# SPARC Enterprise™ T5120 and T5220 Servers Product Notes

### *SPARC Enterprise T5120 and T5220 Servers Site Planning Guide*

**FIGURE 1** Minimum Clearance for Service Access

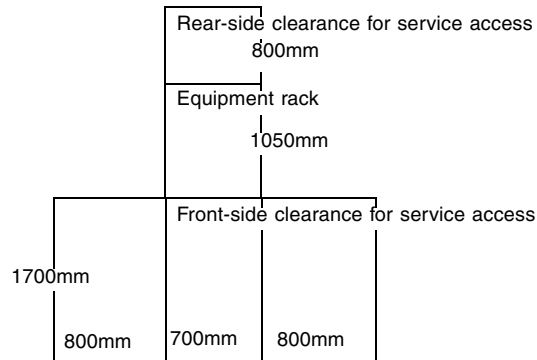
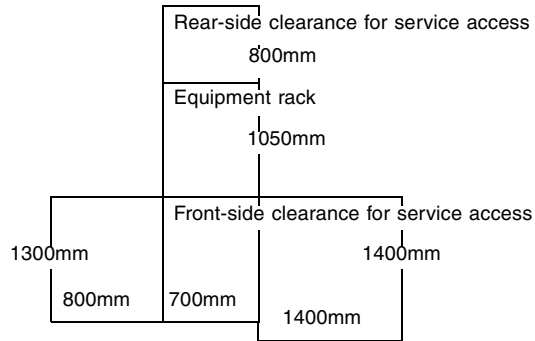
The correct text is as follows:

The SPARC Enterprise T5120/T5220 servers require physical access from the top for maintenance. Therefore, a stepladder may be required depending on which rack the server is installed in. And it may be necessary to remove the server from the rack depending on the component to be replaced.

No stepladder is required if this server is installed at the 20U level or lower. A stepladder is required if it is installed at the 21U level or higher. [FIGURE 1](#) shows the minimum clearance for service access required for either server.

1. If the server is installed at the 20U level or lower (\*1): (\*1 Judged based on the level of the equipment top)

2. If the server is installed at a level between 21U and 40U (\*1): (\*1 Judged based on the level of the equipment top)
